PLANNING APPLICATION PLN-20-0026

19 PEEL STREET, LONGFORD

Description of proposal: Central North Division Police Station (see attached planning report)

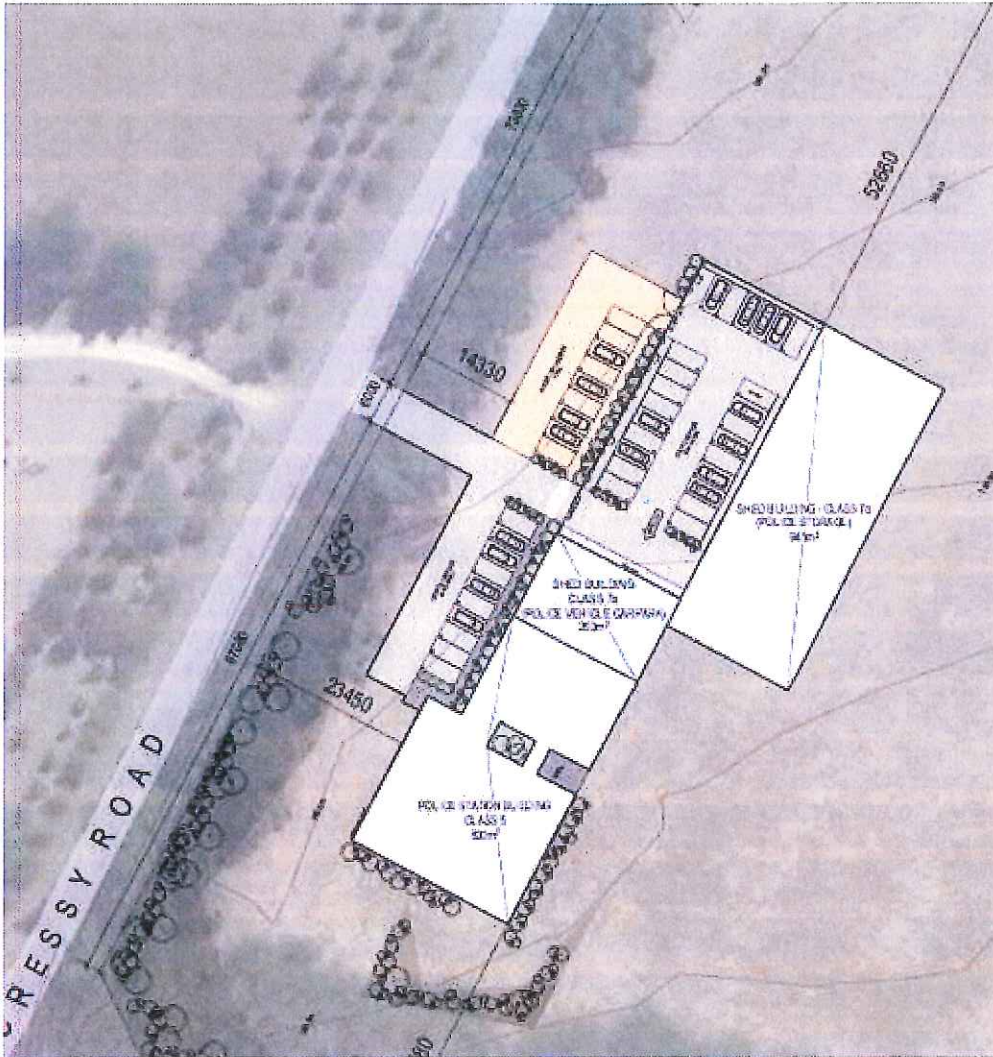
From: keith@midsontraffic.com.au <keith@midsontraffic.com.au>
Sent: Monday, 6 April 2020 5:21 PM
To: Frazer Read <frazer@allurbanplanning.com.au>; 'Rohan Pace' <rohan@hbvarchitects.com.au>; jacob@hbvarchitects.com.au
Subject: RE: 19 Peel Street - police station DA

The driveway is slightly offset from the proposed development access. This is shown in the attached plan. In an urban environment this is considered relatively normal. Sight lines are very good for both accesses and the presence of vehicles entering or exiting either access will be clear and obvious for road users.
